CALL OFFICE CCT. PLAN 5A MODIFIED.
 TO PROVIDE RELAY CONTROL OF OPERATOR RECALL FACILITY
 AUTOMATIC SYSTEM. (UNITS AUTO Nos. 5 & 6).
 EXPLANATORY.

N 2422
 3 PANELS-1
 8-3-57.

CALL OFFICE CCT. PLAN 5A MODIFIED.

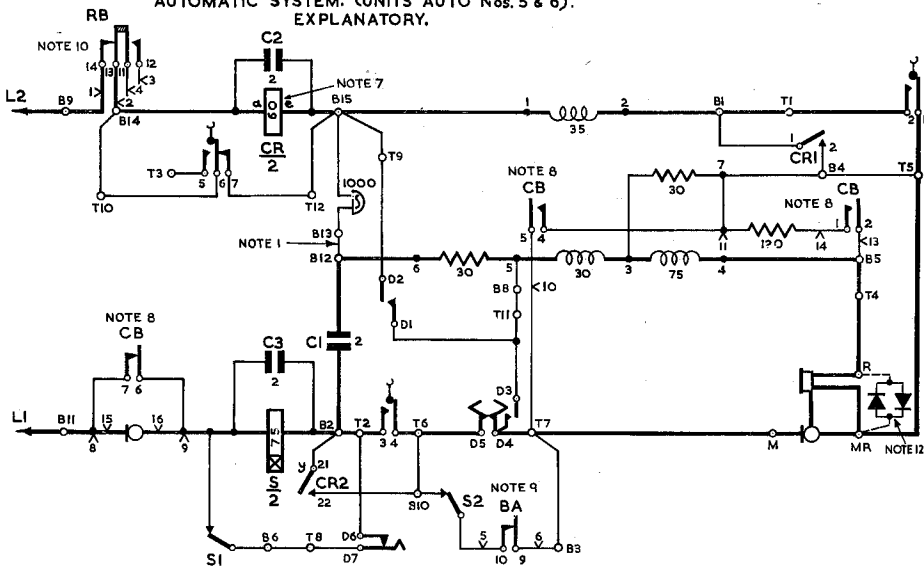
CIRCULATION	SPECIAL.
	SUFFIX
RECT. 101 & NOTES 11 & 12 ADDED.	6.6.67. A
AMENDT.	
PAPER	R

CIRCULATION	SPECIAL.
Suffix	5.5.67.1A
Amend.	RECT. 101 & NOTES 11 & 12 ADDED.
PAPER	R

10. THESE SPRINGS ARE OPERATED BY DEPRESSION OF THE "B" (REFUND) BUTTON.
11. THE FRAME OF THE COIN BOX MECHANISM MUST BE EARTHED BY CONNECTING SPRING 8 TO THE FRAME TAG ON THE SPRING SET (SEE ALSO E.I. TELES. C.O. D3003).

12. ON PUBLIC CIRCUITS, FIT TWO RECTIFIER ELEMENTS No. 101, SUITABLY INSULATED, IN THE TRANSMITTER CAVITY OF THE TELE. 164.
